York Street Interchange

Vector Re Routing
Proposal
Assessment

October 2015

Drawing Number
DRAWING 5
 Rev

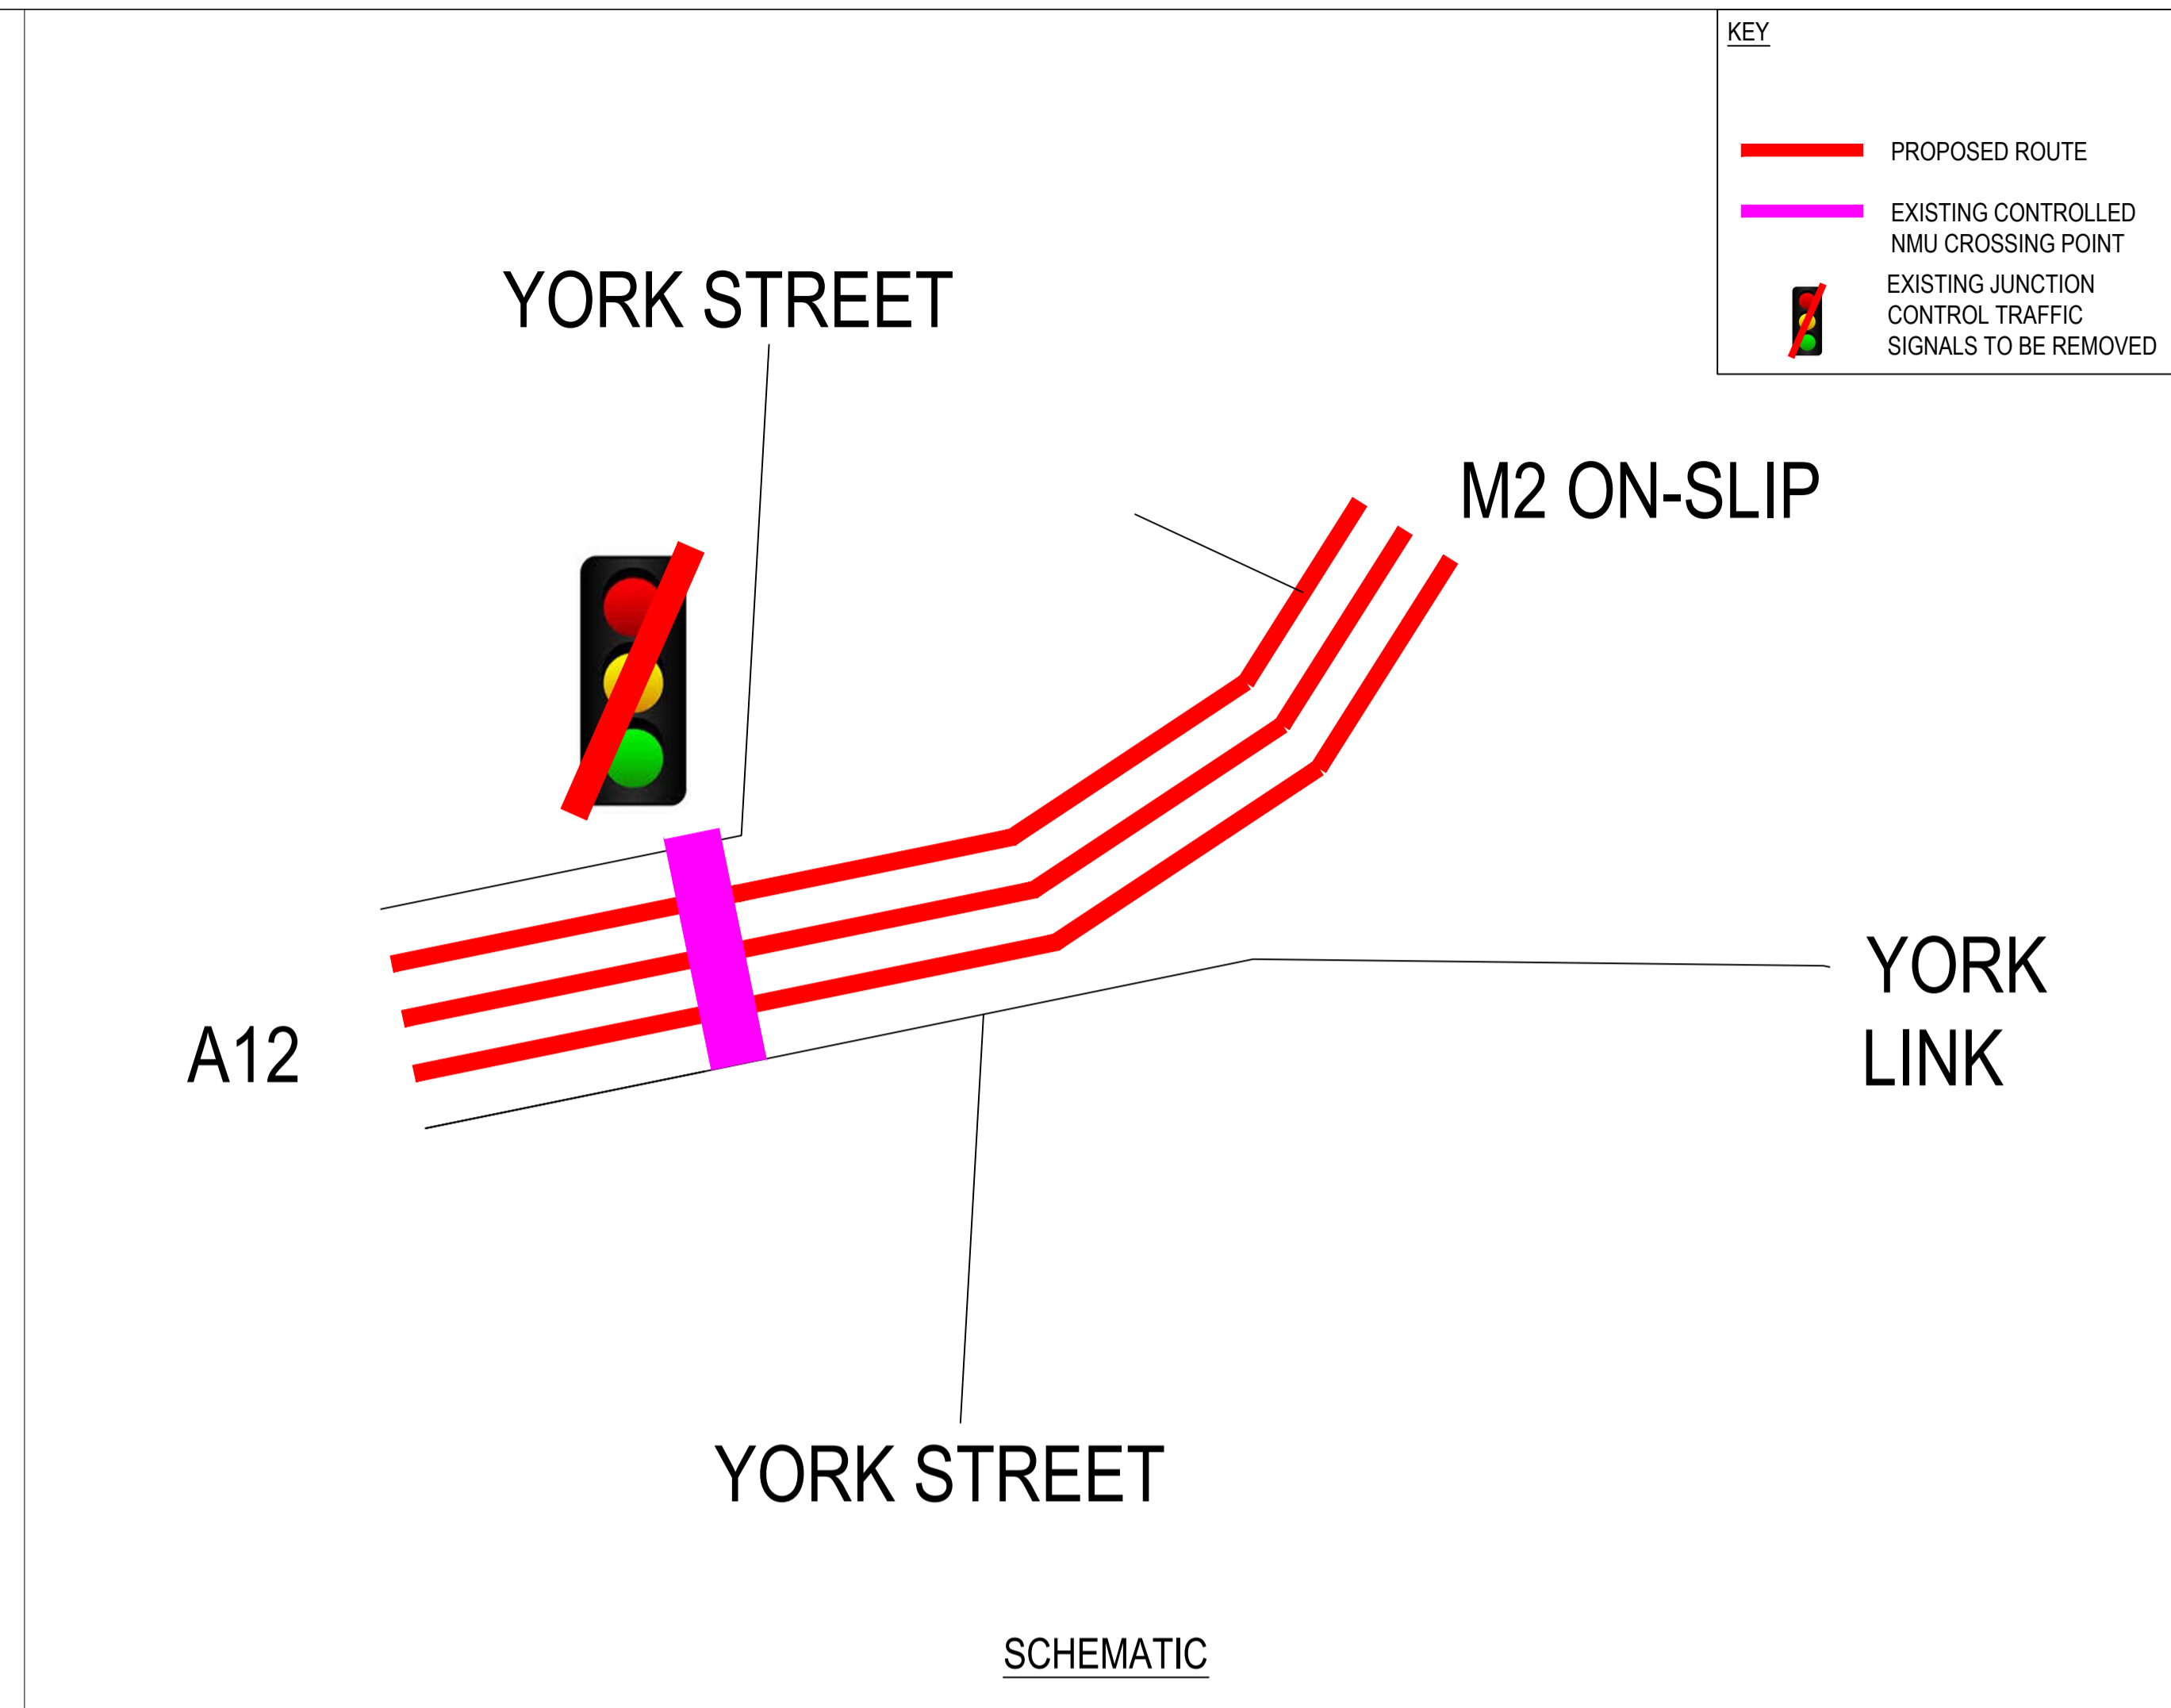
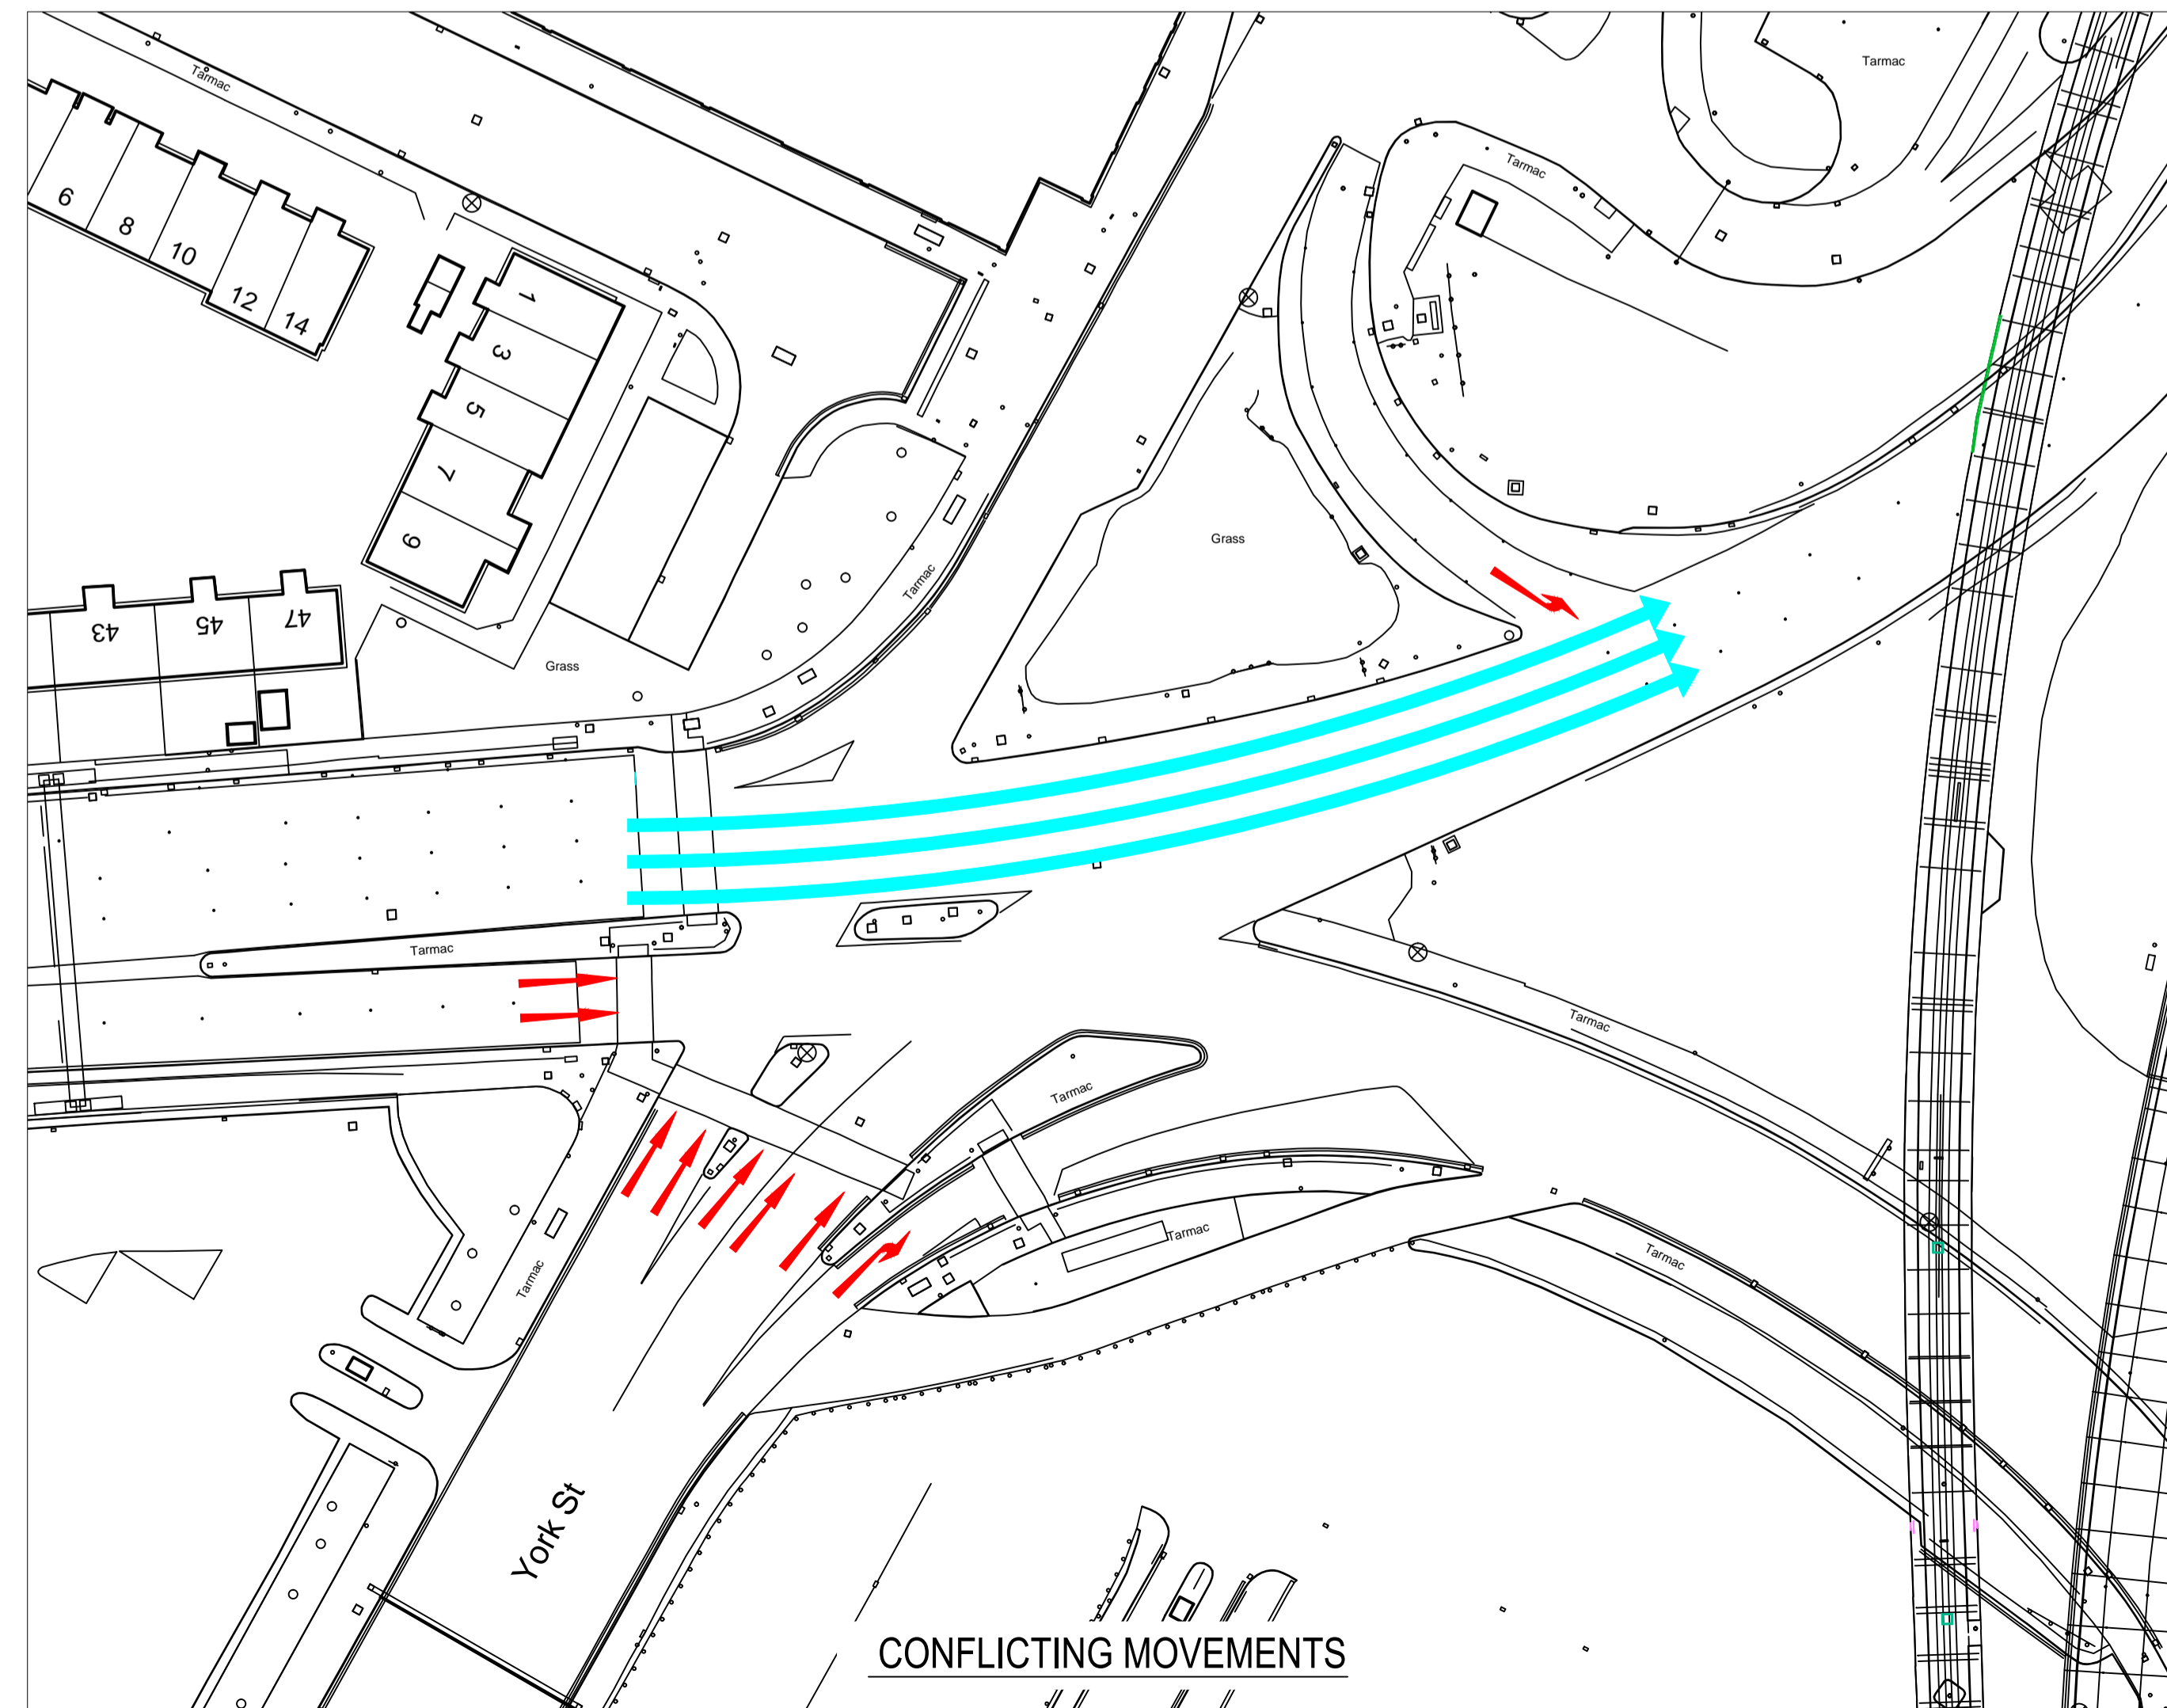
Drawing 5 in Appendix A illustrates the Vector Proposal, along with a schematic diagram illustrating existing lane provision on the original and diversion routes.
